Request for Class II Permissive Change

FCC ID: AJY2023FCS950U

The original grant date: 03/15/2024

Original Antenna	New Antenna

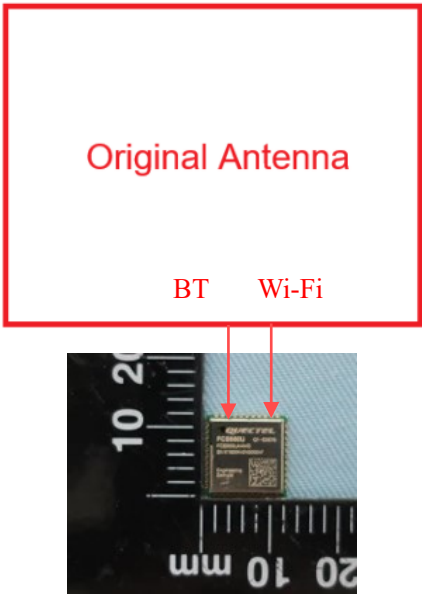
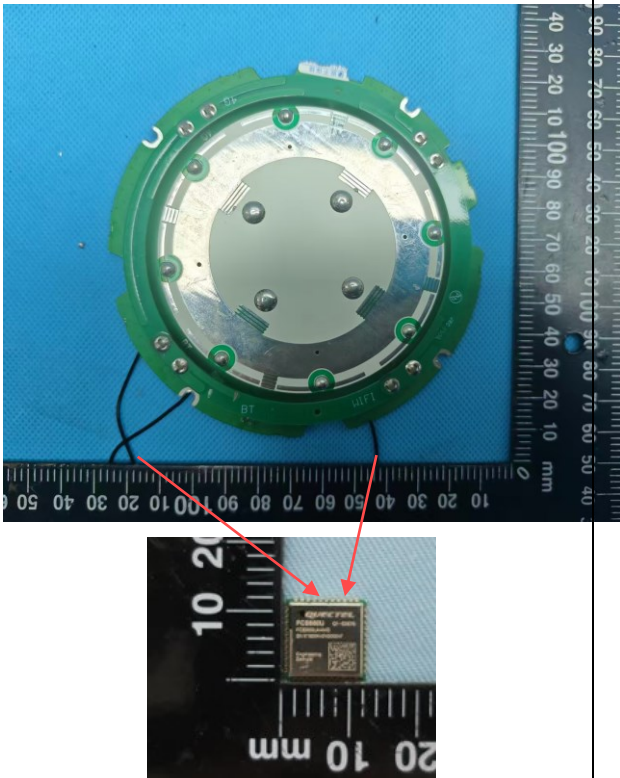
Replacing new Integral Antenna with lower antenna gain (0.5dBi Max@2410 to 2480MHz, -1.2dBi Max@5150 to 5850MHz) from the original dipole antenna (0.73dBi Max@2400 to 2483.5MHz, 1.14dBi Max@5150 to 5850MHz).
